RESOLUTION NO. 14-197

**A RESOLUTION AUTHORIZING THE CITY OF PORT ARTHUR SECTION 4A ECONOMIC DEVELOPMENT CORPORATION TO ENTER INTO A PROFESSIONAL SERVICE CONTRACT WITH HADDON + COWAN ARCHITECTS COLLABORATIVE OF AUSTIN, TEXAS, WITH VINCE HAUSER AS THE DESIGN TEAM MANAGER IN AN AMOUNT NOT TO EXCEED \$21,000 WITH A REIMBURSABLE EXPENSE FEE NOT TO EXCEED \$1,500.**

RE: Port Arthur Savings Building / 501 Procter  
Proposed revisions / Texas Historical Commission review

NOTES: Request cost and budget impact for proposed design revisions

**SK1 FLOOR PLAN**  
 SCALE: 3/16" = 1'-0"

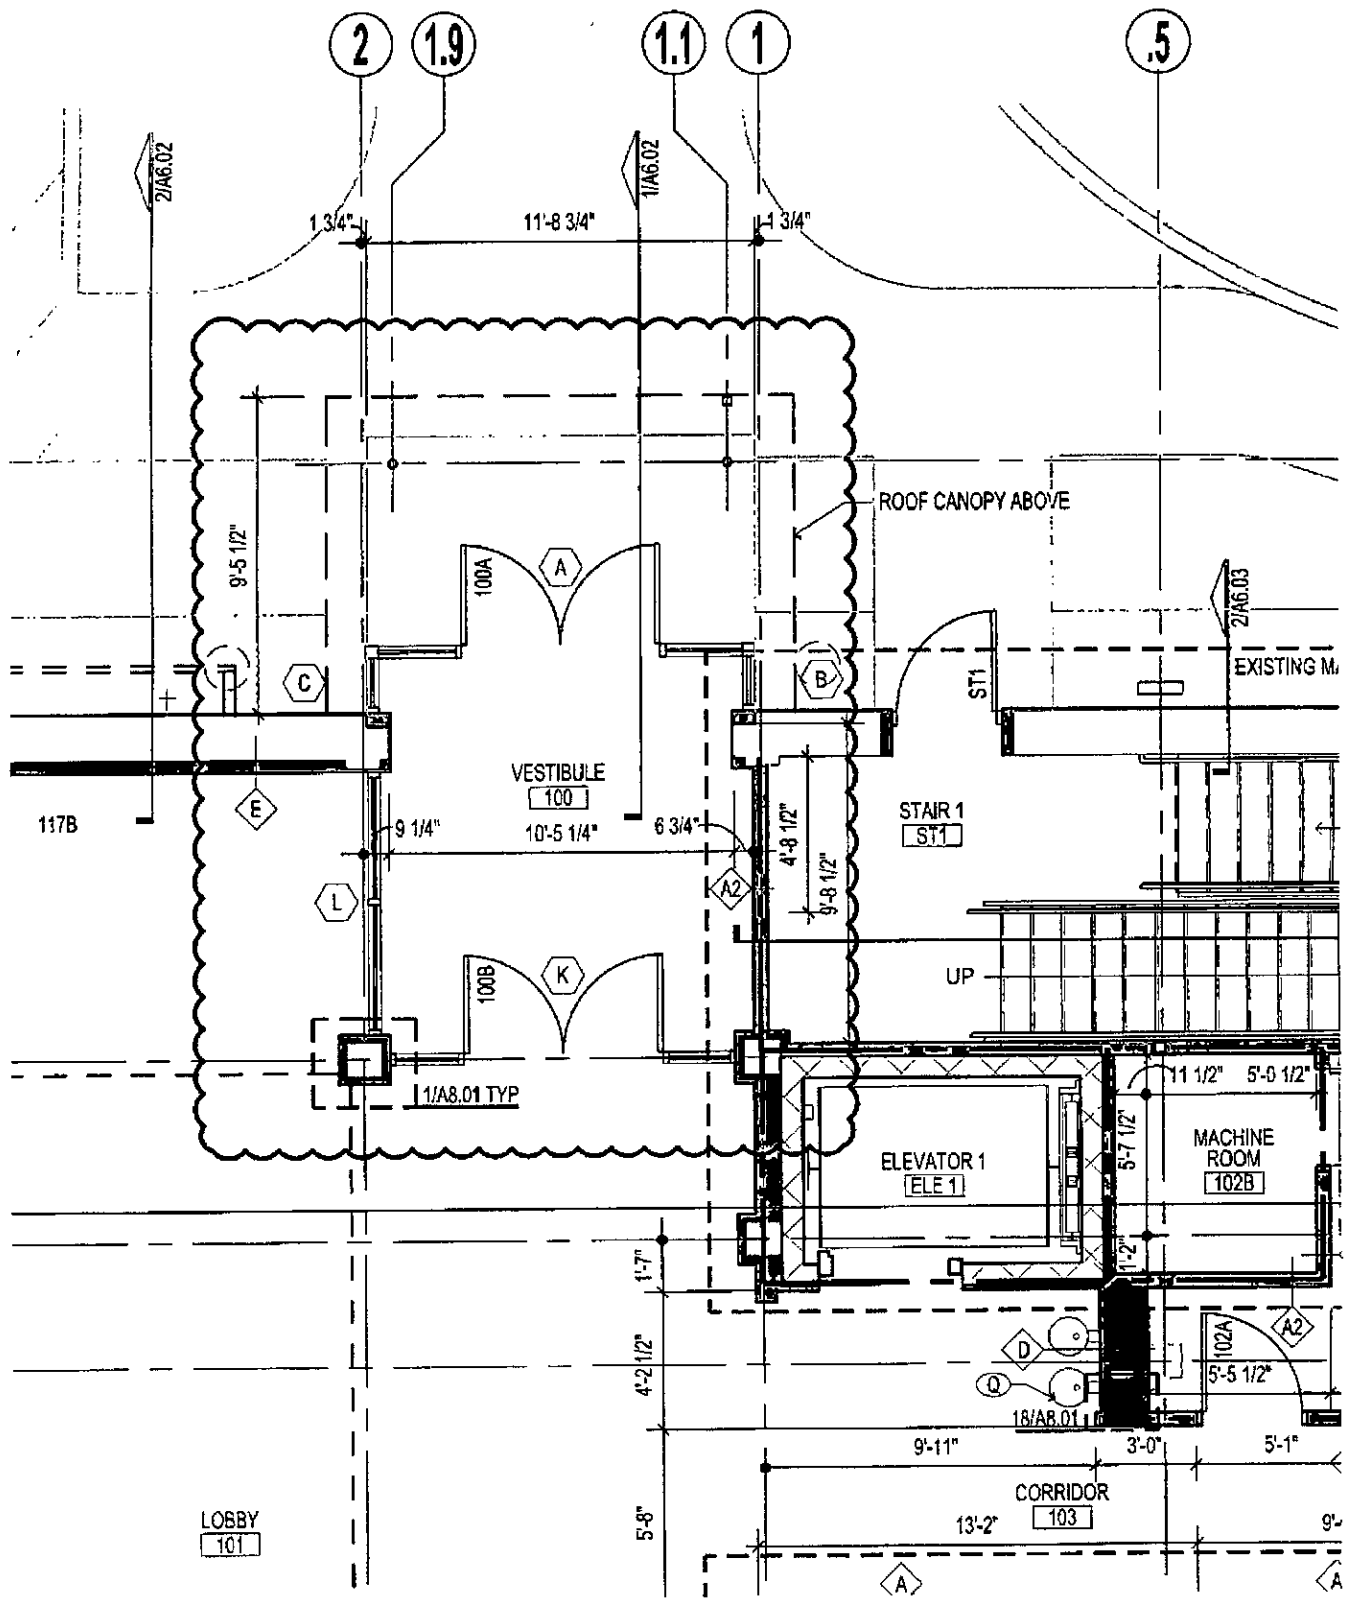
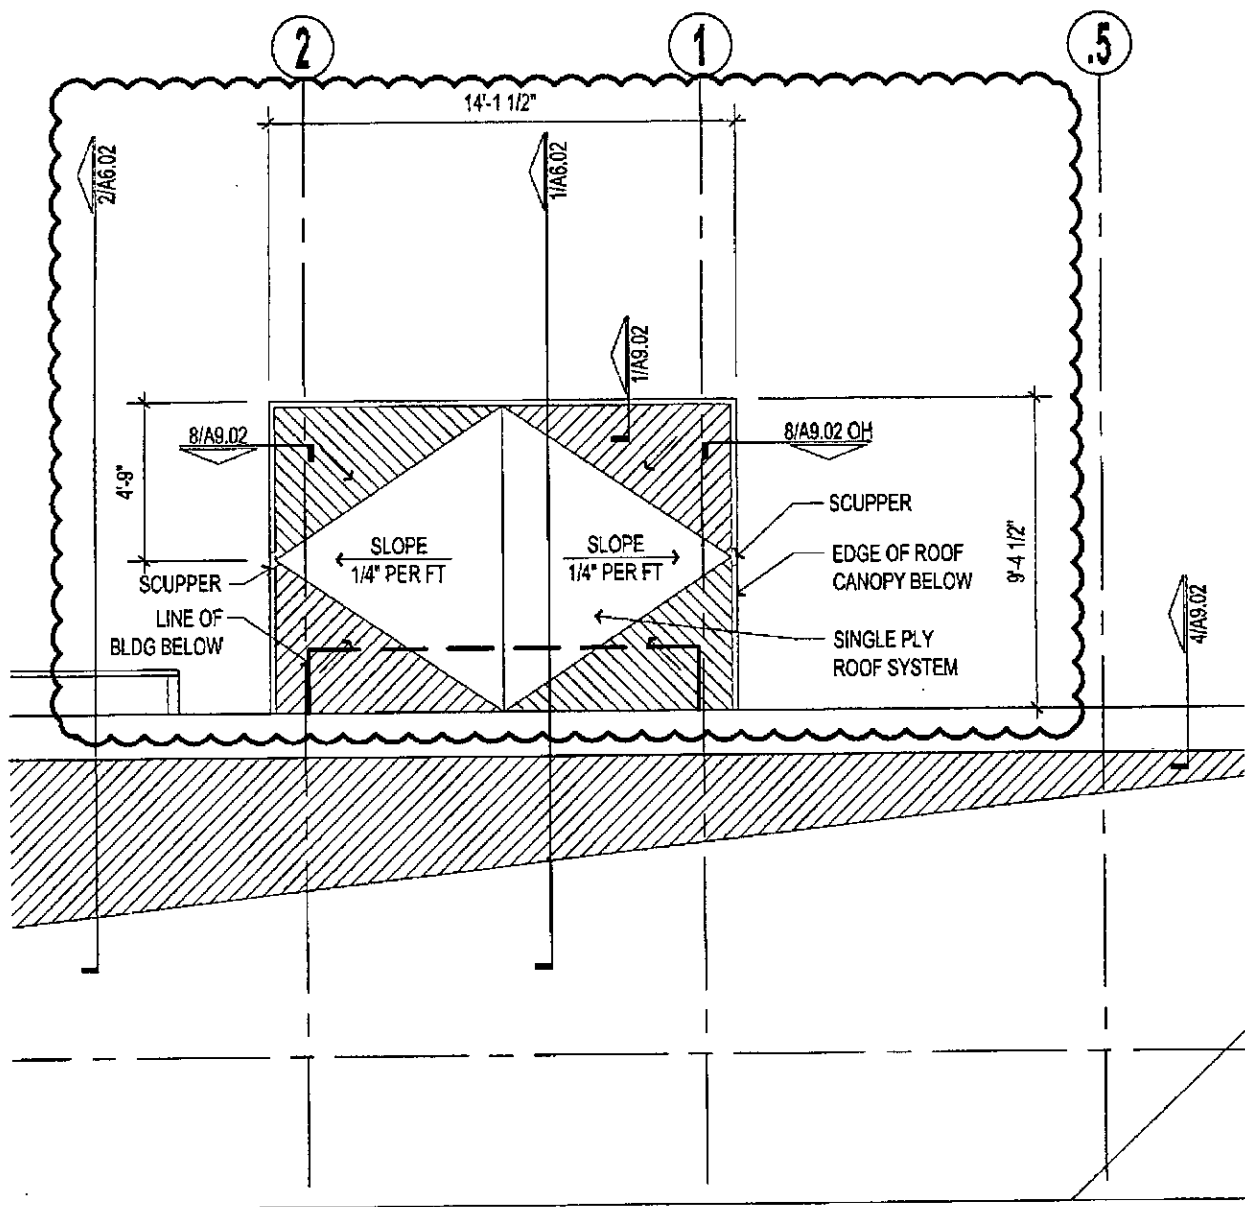
1. Revised entry on the east façade of the building, see SK's attached
2. Relocate storefront from the front of the Procter St façade to its current historic location. No SK provided.
3. Revisions to historic windows on Procter and Austin Street building elevations to include retaining, refinishing and re-glazing existing casement windows. See SK's attached
4. Revisions to HVAC and other mechanical systems as a result of the changes above. See LaMette narrative provided
